OFFICIAL COORDINATION REQUEST FOR NON-ROUTINE OPERATIONS AND MAINTENANCE

COORDINATION TITLE- 17TDA17 Rail removal west powerhouse COORDINATION DATE- May 15, 2017 PROJECT- The Dalles Dam RESPONSE DATE- May 24, 2017

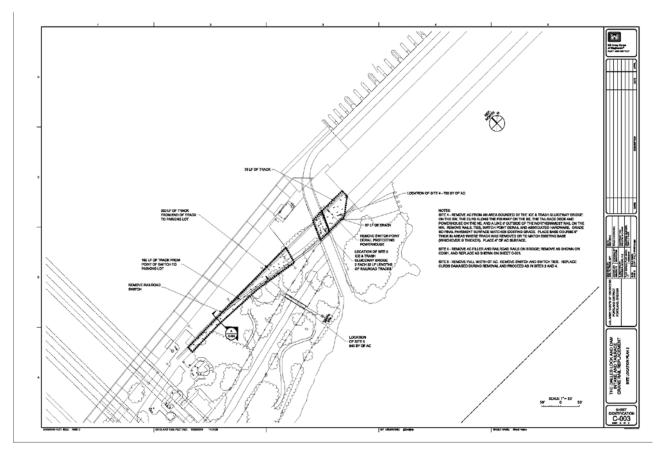
looking at this it should be ok, however make the following recommendations; do the actually concrete part of the work (jack hammering) at night or late in the day say after 3 o clock. It looks like the actually concrete part of the job should be fairly small and not take much time. If they have problem with this let me know and we can come up with something, say wait until the in water work period, ok maybe not that long. Will be out until Monday so do not be surprised if you do not receive anything else from me in the next couple of days...

Final Action: FPOM concurred with this action at the June meeting.

After action update: Completed. All rail in asphalt removed. Rail in concrete section to be removed during in water work period.
